Number	QUESTION	ANSWER
01	Has there been a drainage survey?	The rear drains have been camera surveyed. These will require renewal to the outfall as part of future phase of work not Phase One. The drains to the front of the building that fall under Phase One have not been surveyed. It is thought that one drain exists from the east down pipe via a salt glaze gully.
02	Where are the new drains to discharge and have Wiltshire Highways been consulted?	The intention is to re-use the existing connection at the east end and to add a branch to this. The condition of the drain is unknown, so the proposals are to renew existing and add new where shown. The proposals are based on renewal of existing and do not increase the volume of water discharging to the highway or sewer. One works commence it will be possible to take a closer look at where the drains connect.
03	<u>Prefix 3.3.2</u> – Is there any reason for using clay drainage pipes?	For deeper drains. Alternatives can be proposed as a cost saving variation post tender. Please price the schedule as specified and if you wish include a list of potential cost saving material variations appended to your tender.

THE HOP POLE, LIMPLEY STOKE

11655_SK11_P2

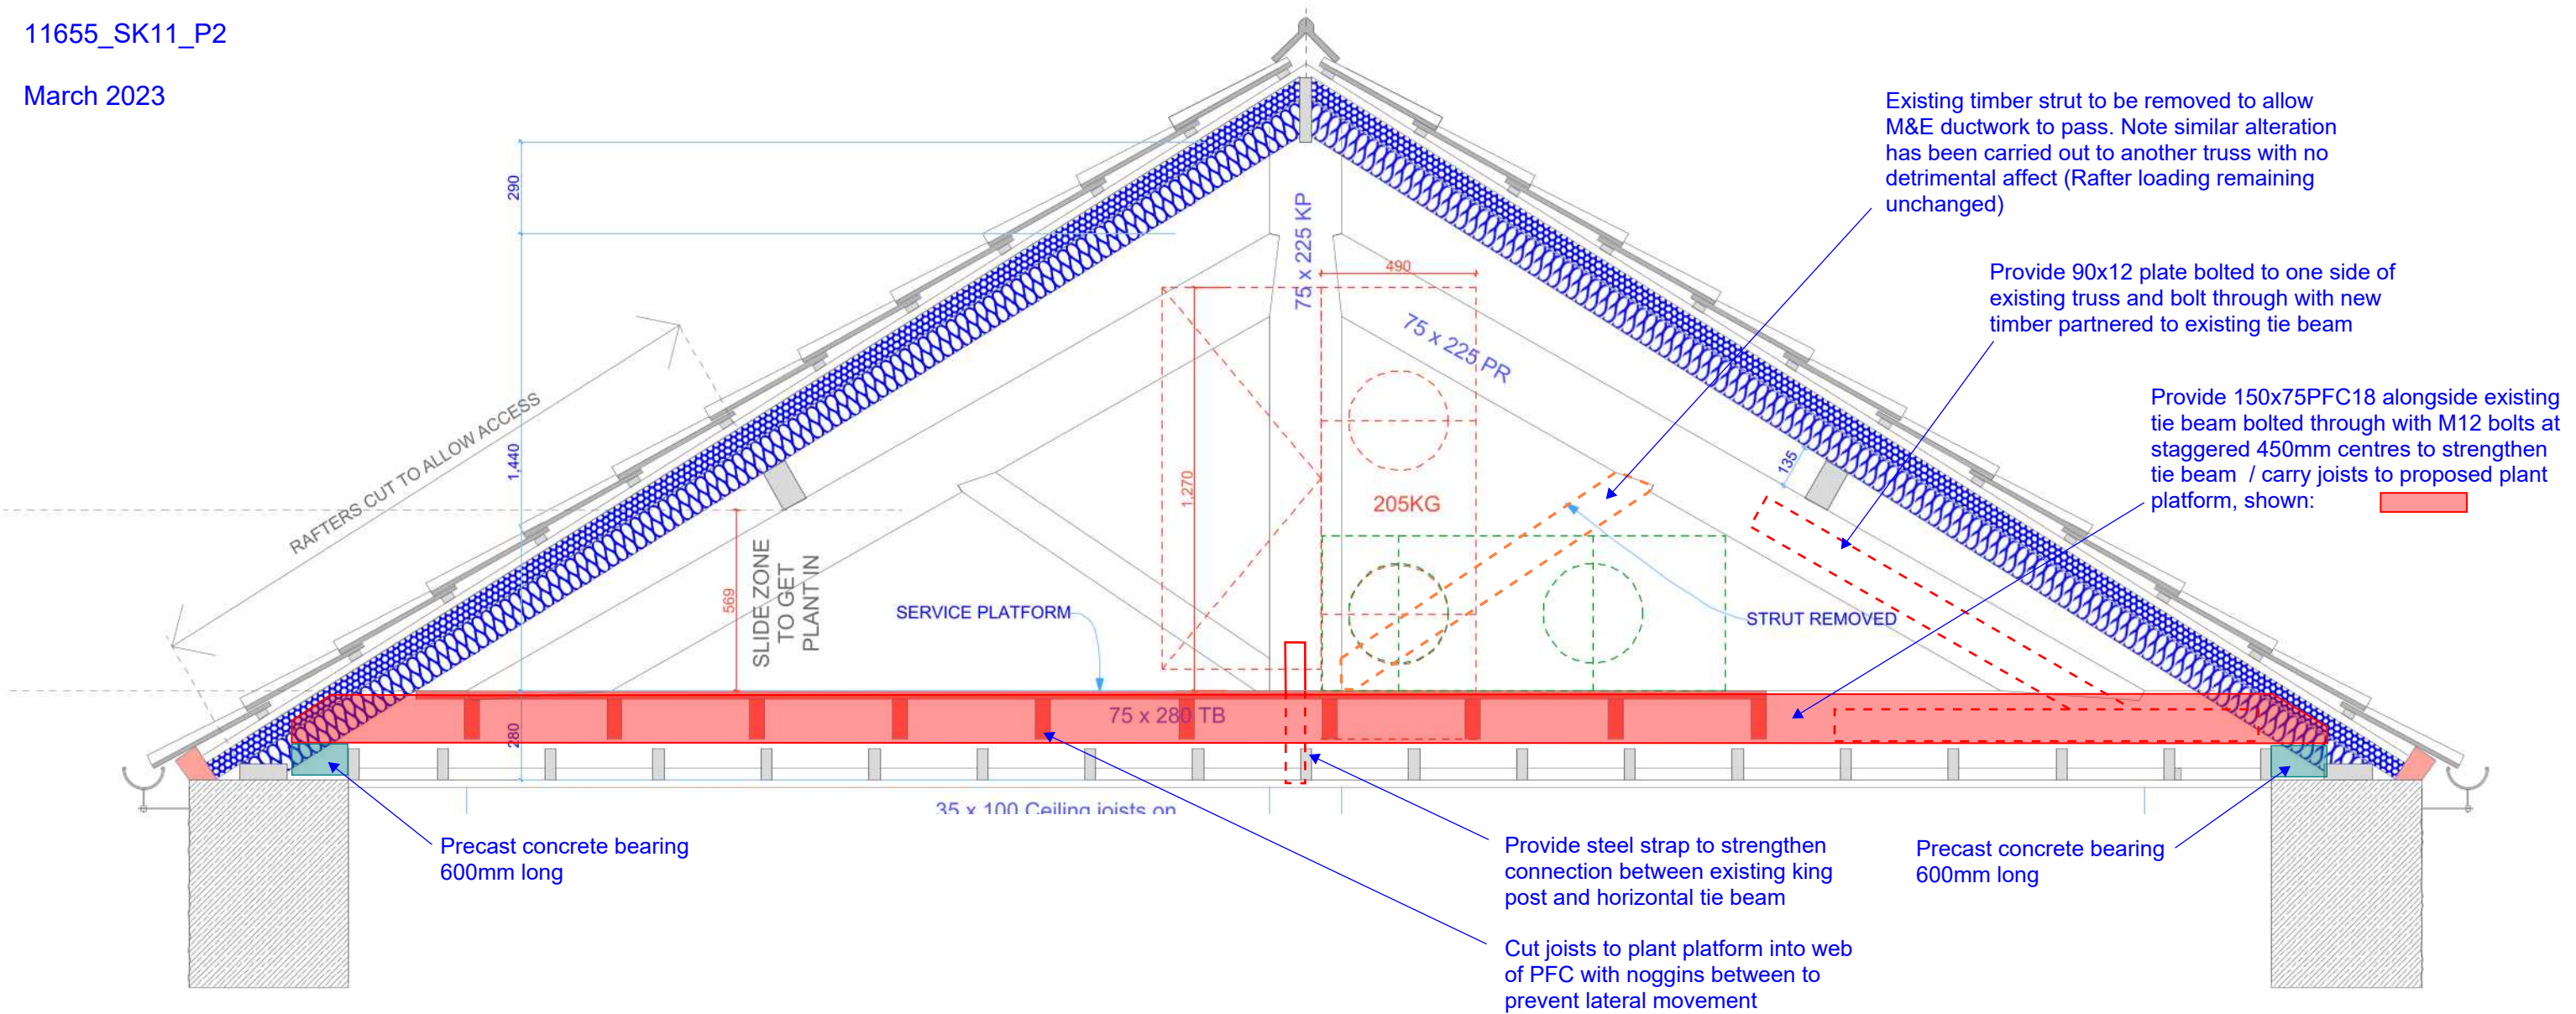
We need to add air conditioning units to the loft space. The biggest unit is 1270 x 2020 x 490mm and weighs 205kg. this will have to be supported on a seperate structure as shown as the ceiling joists are tiny. The free span of this floor is about 2.7m. Timbers need sizing please

We also need to get these units in. The most logical thing is to cut a number of rafters and slide the unit below the purlin. This may change the loading on the purlin so it would be good to know if we need completely new rafters. (currently an awkward size).

The third element of the design requires us to introduce some big ducts. To ease the options in configuration we need to remove one of the struts to the KP truss. We may be able to add a strut below the purlin if this helps.

We have spoken to Airflow developments and they prefer their units to be accessed from the front. They are replacing the DV1600 with the DV1700 which is the same size but has bifold doors making access easier. The swing on these doors is 500mm as opposed to 1000mm. This means that the unit can be set vertical. the feet are removable and it can be mounted directly on an acoustic mat. (red dashed line)

11655_SK12_P2

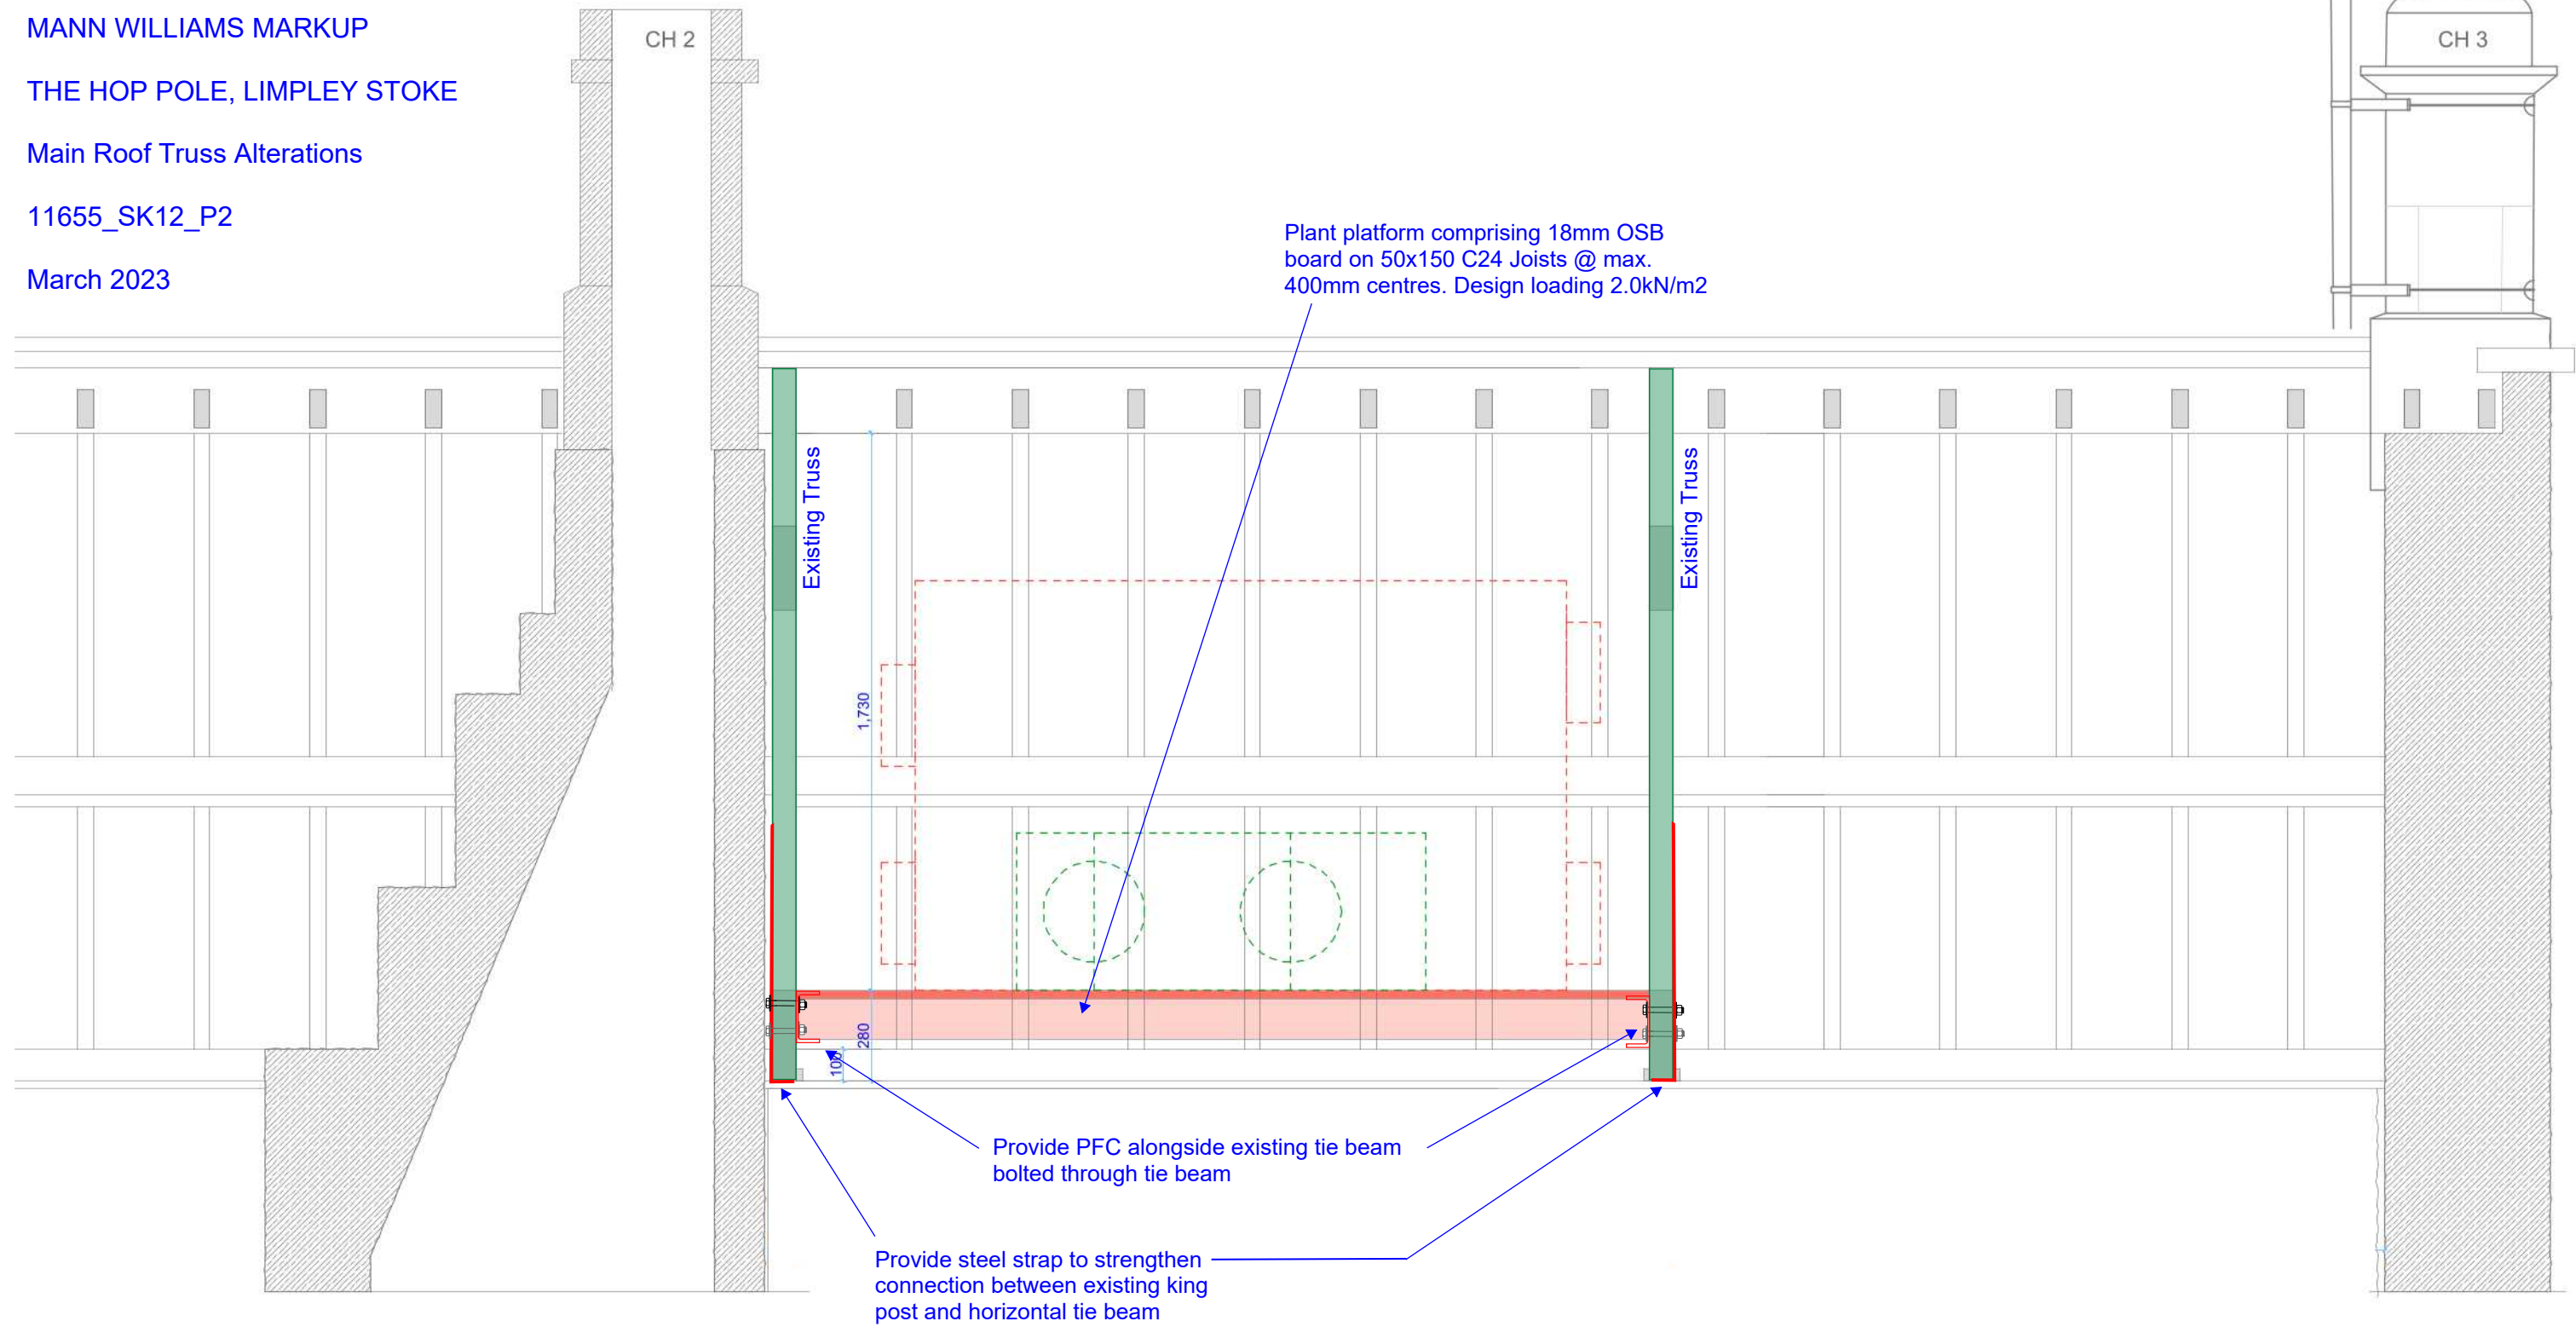
Engineering input required:
We need to add air conditioning units to the loft space. The biggest unit is 1270 x 2020 x 490mm and weighs 205kg. this will have to be supported on a seperate structure as shown as the ceiling joists are tiny. The free span of this floor isabout 2.7m. Timbers need sizing please

We also need to get these units in. The most logical thing is to cut a number of rafters and slide the unit below the purlin. This may change the loading on the purlin so is would be good to know if we need completely new rafters. (currently an awkward size).

The third element of the design requires us to introduce some big ducts. To ease the options in configuration we need to remove one of the struts to the KP truss. We may be able to add a strut below the purlin if this helps.

M&E input required:
We have spoken to Airflow developments and they prefer their units to ba accessed from the front. They are replacing the DV1600 with the DV1700 which is the same size but has bifold doors making access easier. The swing on these doors is 500mm as opposed to 1000mm. This means that the unit can be set vertical. the feet are removable and it can be mounted directly on an acoustic mat. (red dashed line)
